# **TELESTAR**

## **CHASSIS PT-220**

## **What we changed from PT-200 to PT-220?**

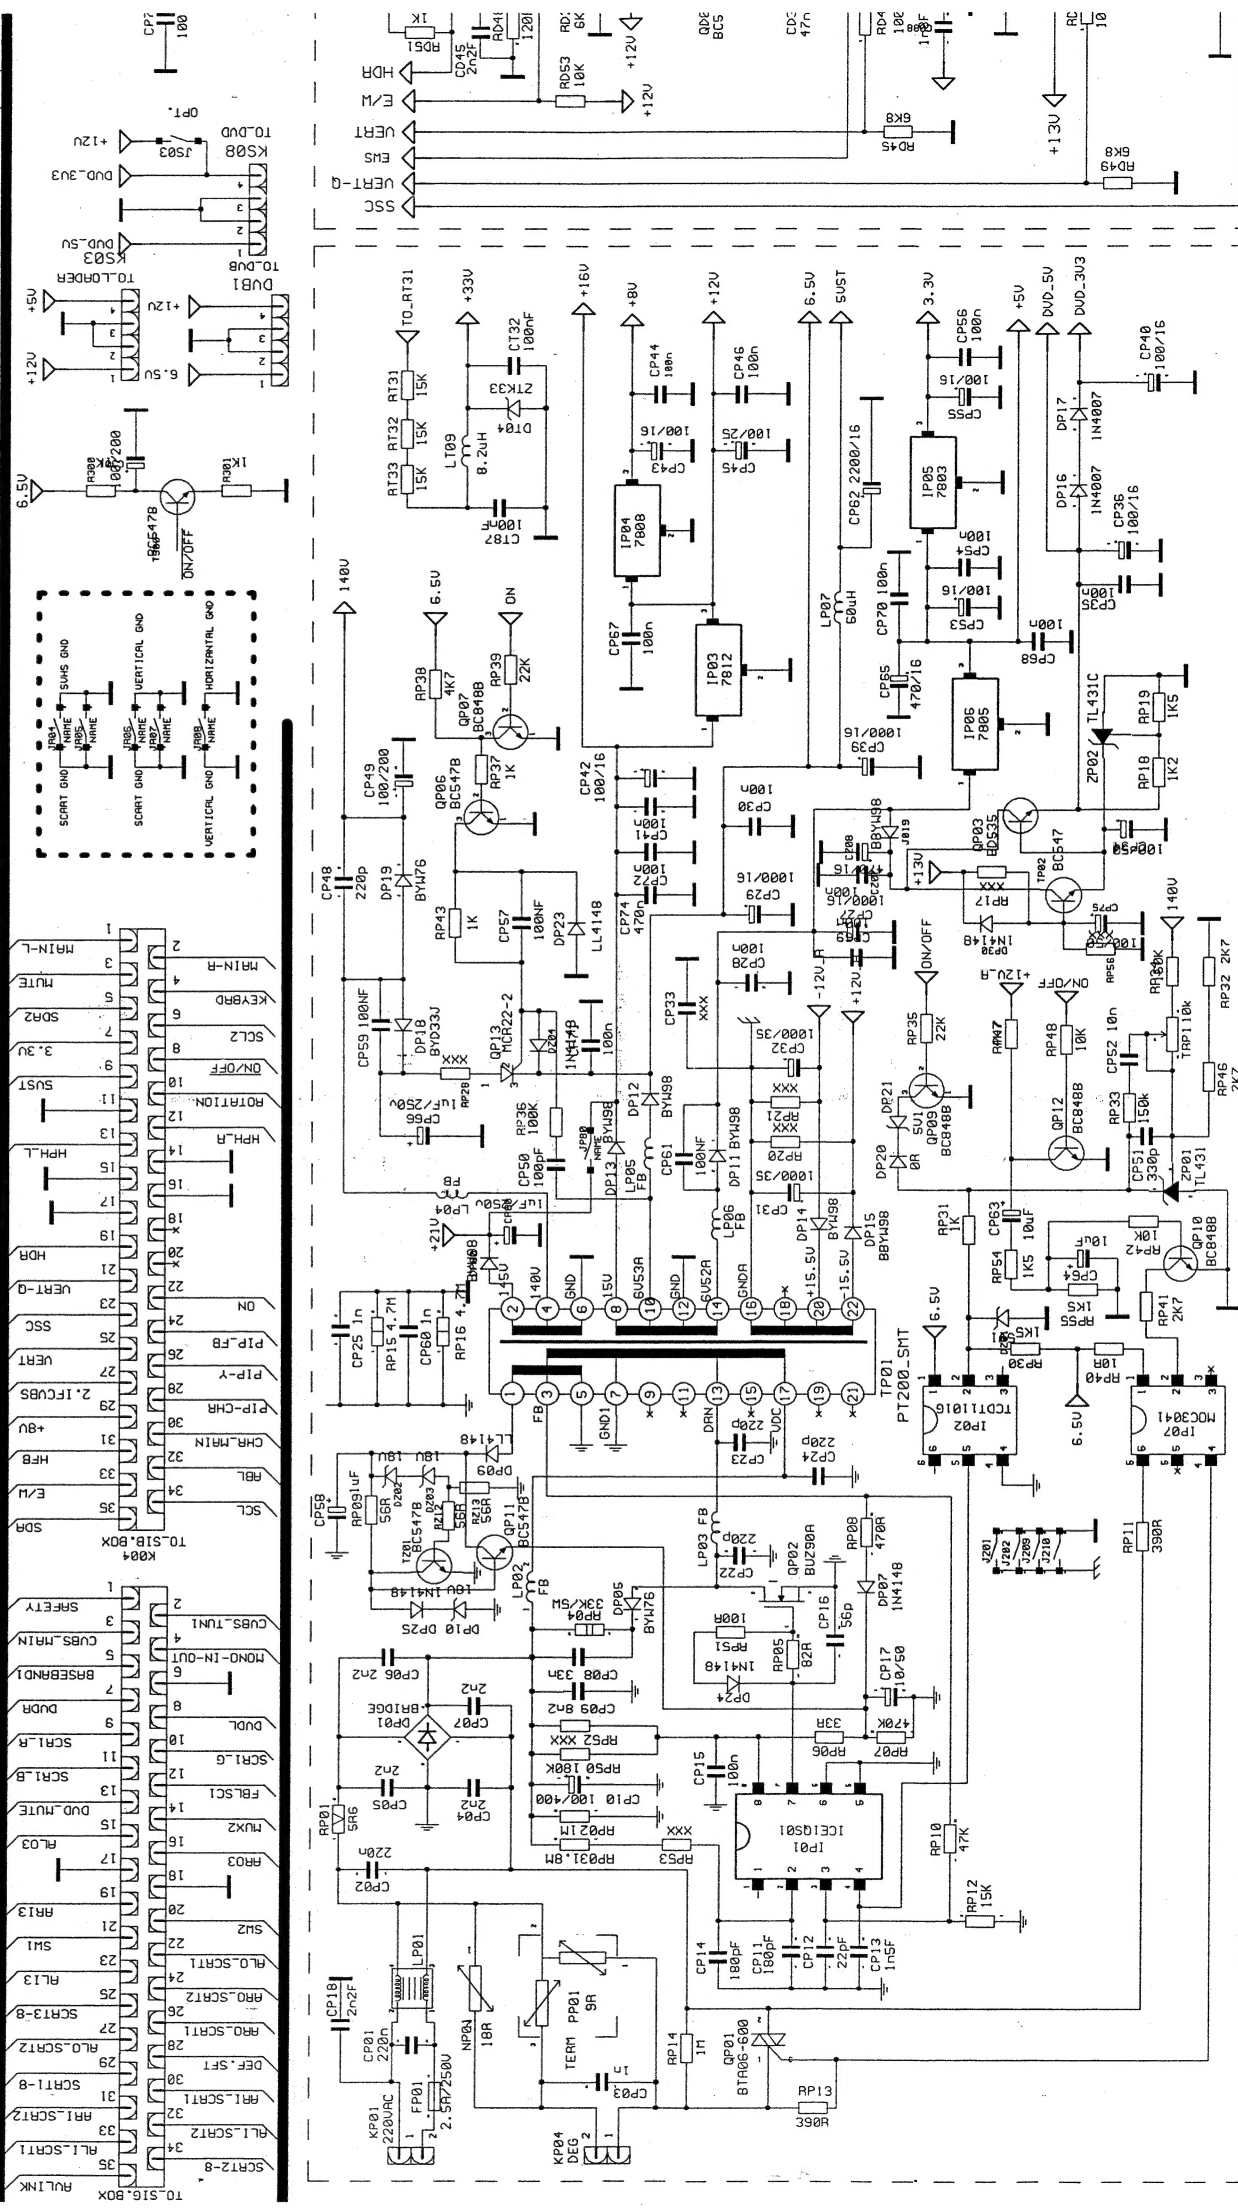
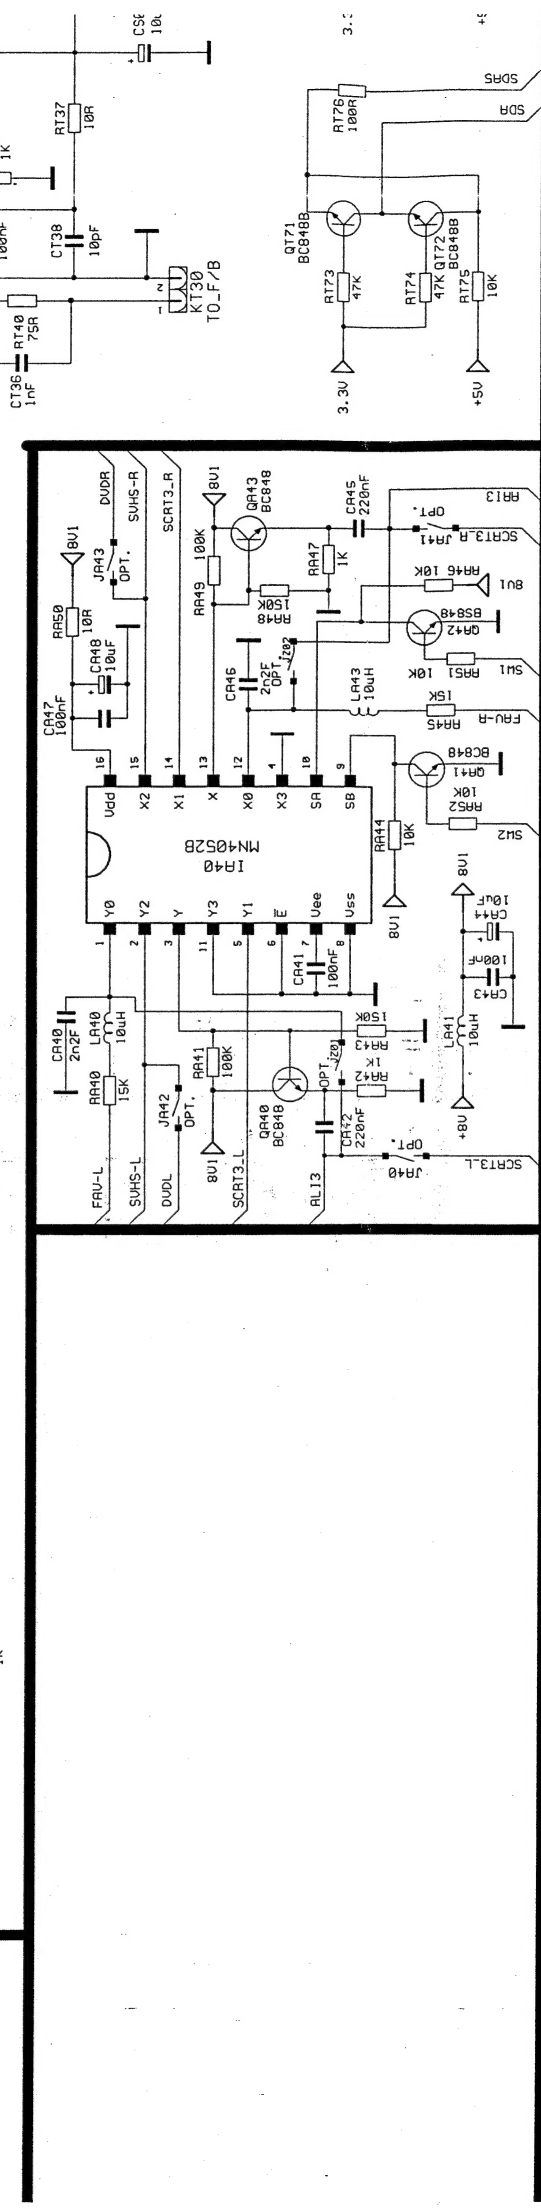
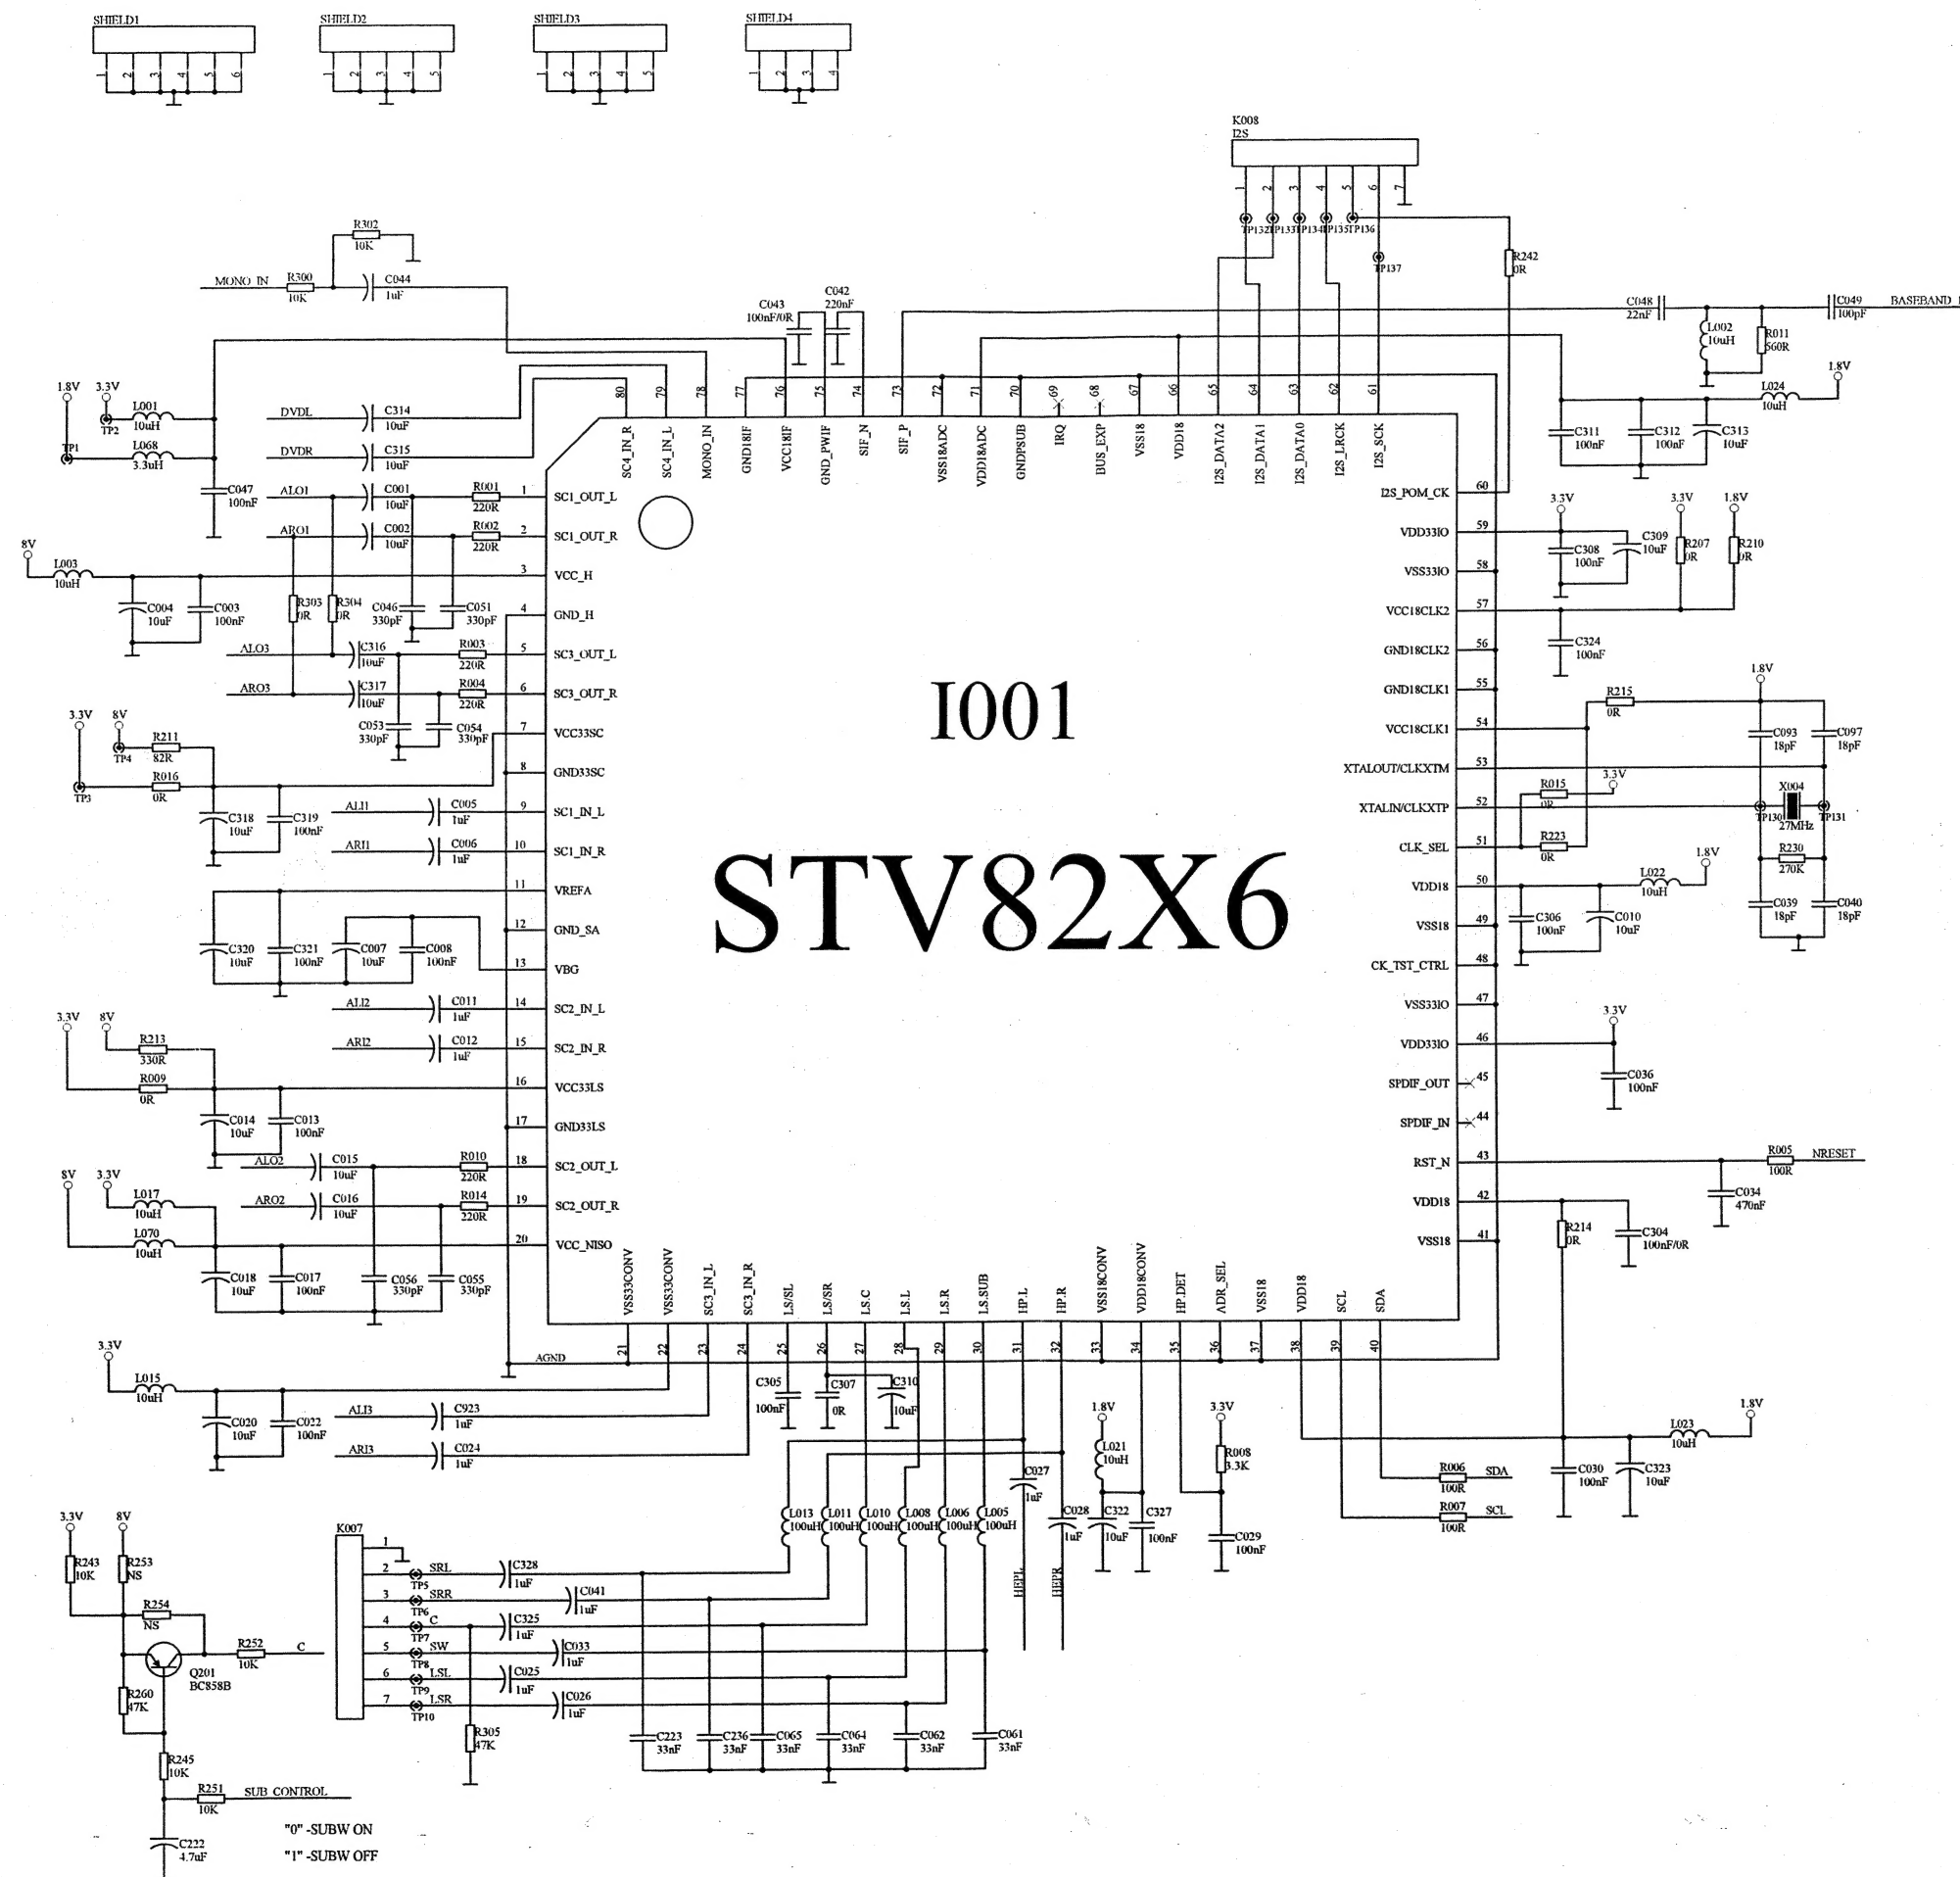
- We replaced STV3500 microcontroller with new version STV3600
- We replaced SDA9589 PIP IC with second STV2310
- We deleted RGB swithing IC PI5V330
- We deleted 74AHC1G08 IC
- We added 74V1G125 and 74LCX244T IC's to the chassis which has PIP feature
- We replaced the Flash IC M29KW016E with M29W160ET type
- We replaces 2 pcs K4S621632F-TC72 RAM with 1 pc K4S281632F-TC75 RAM
